PLANNING DEPARTMENT – Development Review Services

**RE: Signal Pointe Subdivision
Pad Certification – All Pads
Engineer's Stamp Date 7-21-2016 (File: C20D0070)**

GRADING & DRAINAGE PLAN

Grading & Drainage Plan

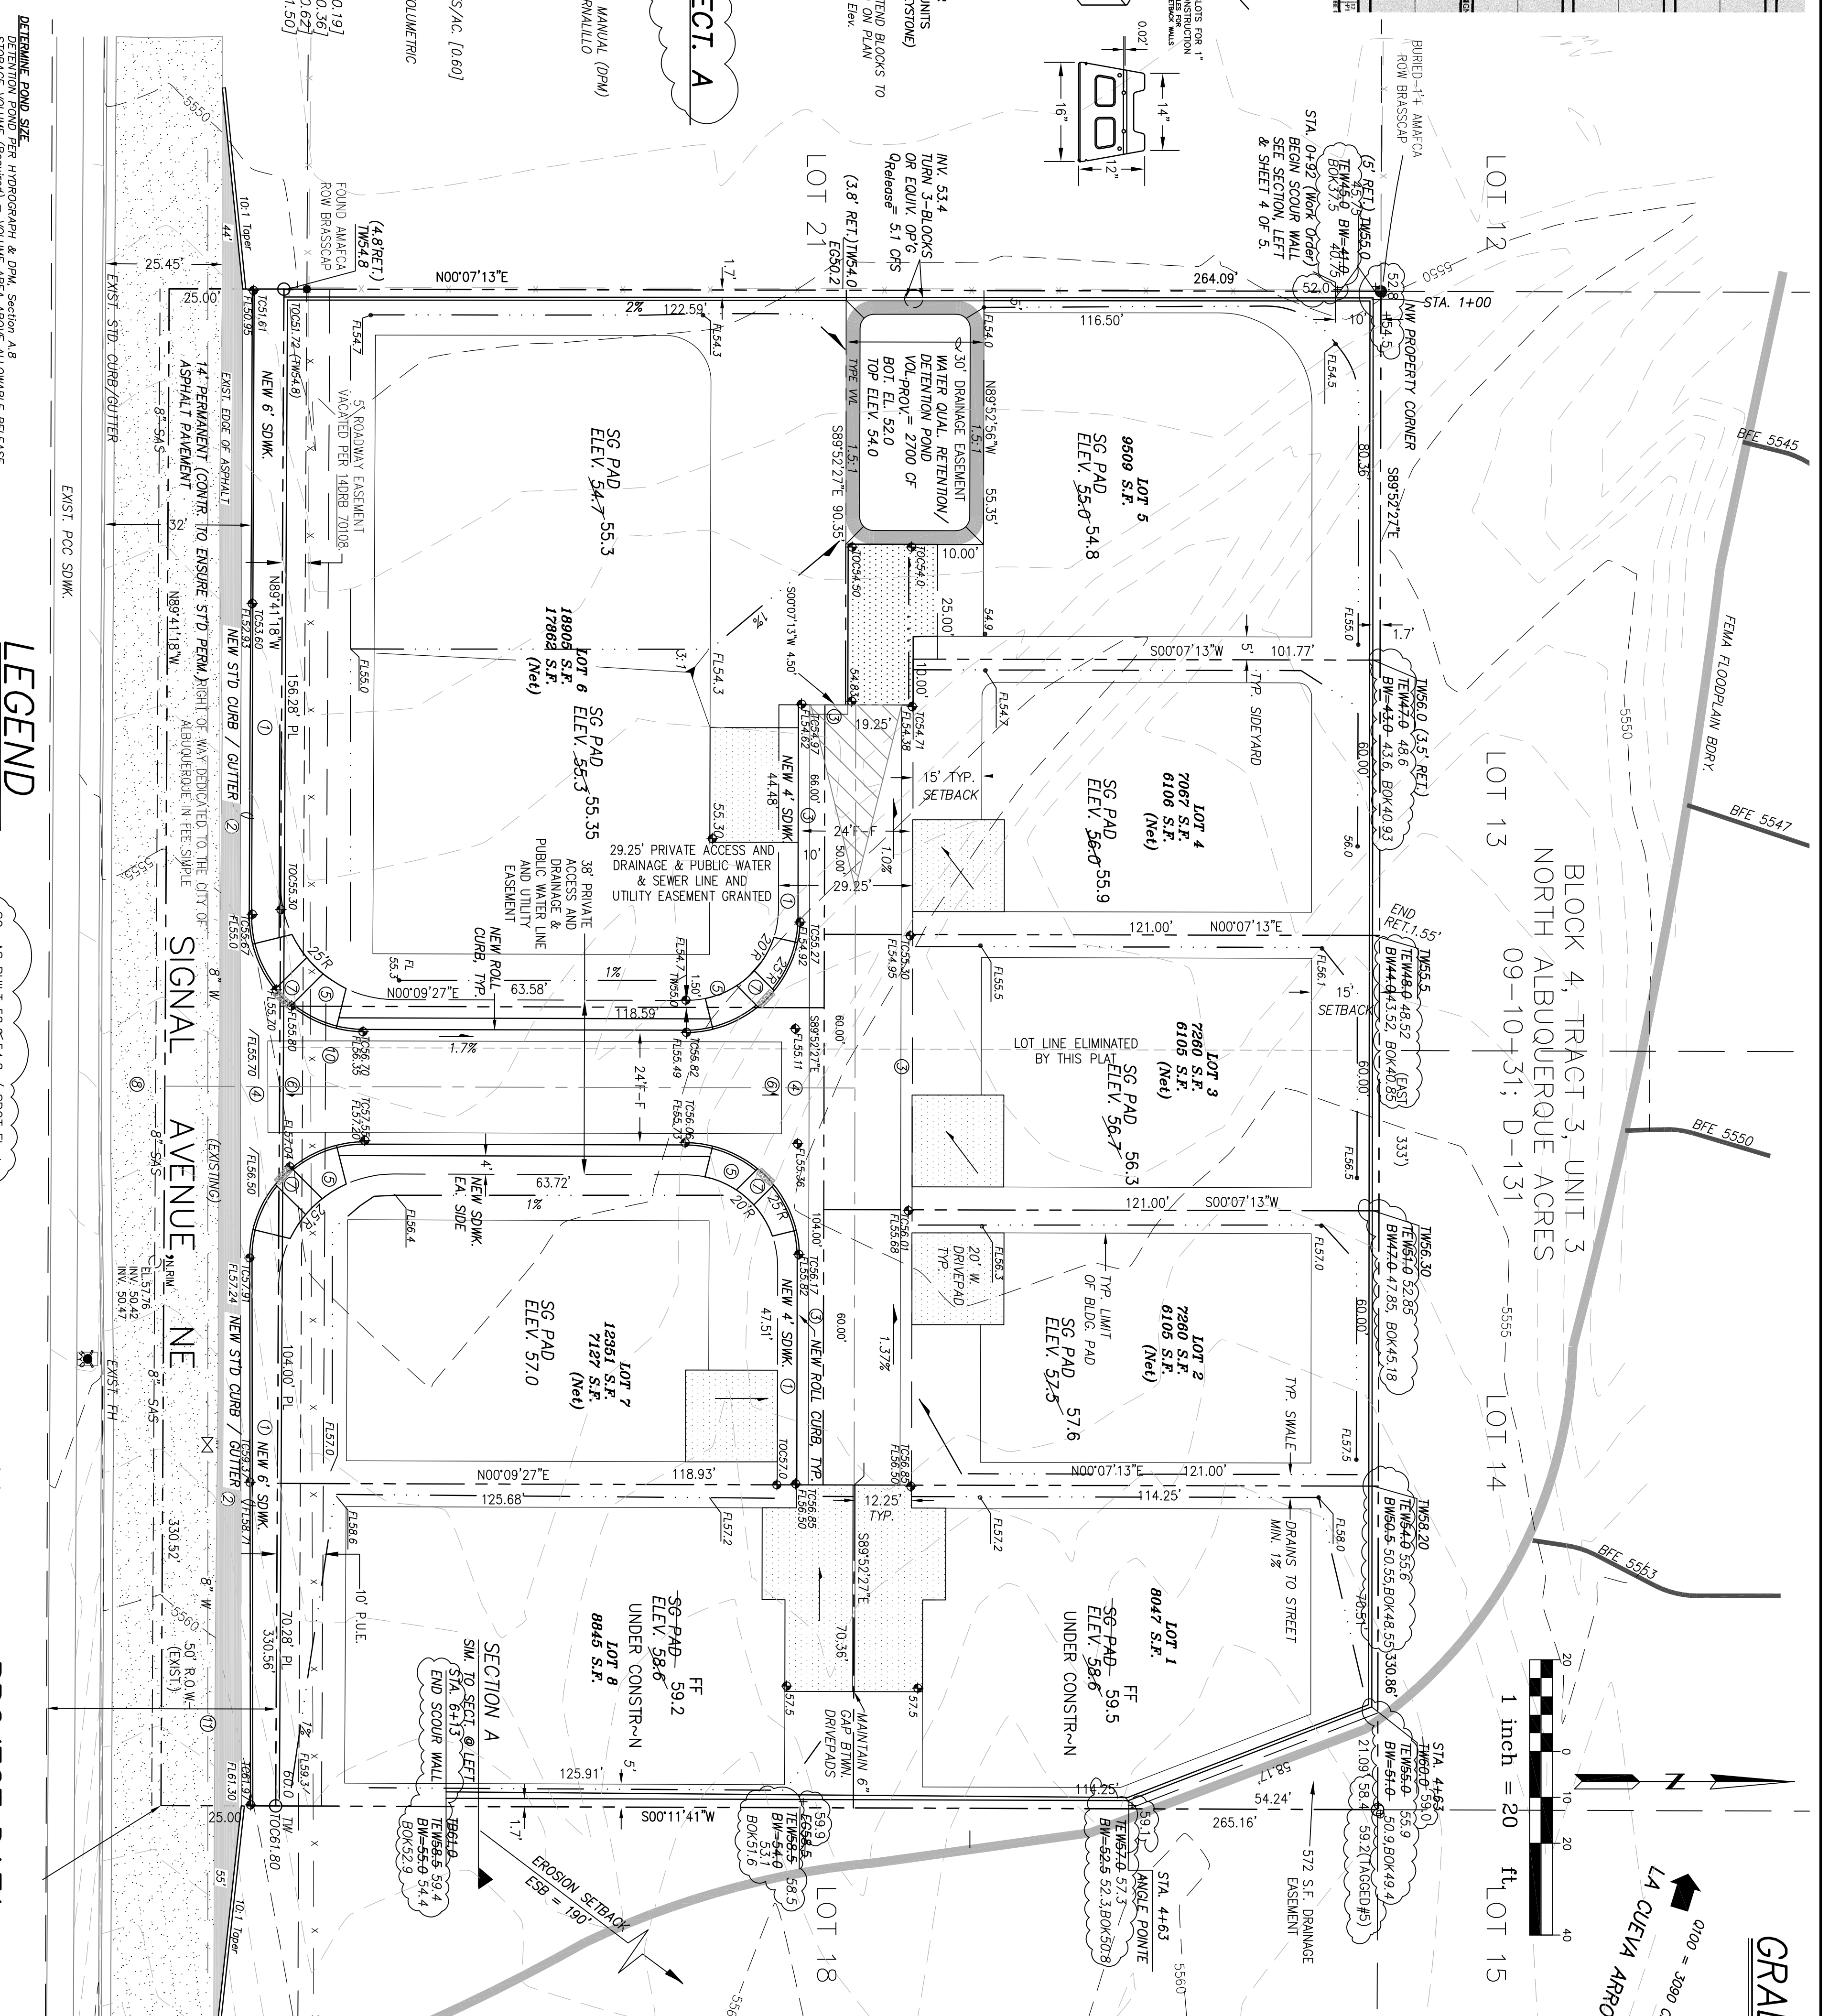
1. The turn blocks were not incorporated into the western wall, as an outlet for the water quality pond. This has the potential to adversely affect the home that is currently under construction on Lot 5 when the subdivision is built out. This will need to be addressed before any further action on this subdivision is approved (final plat, ROFG, future building permits).
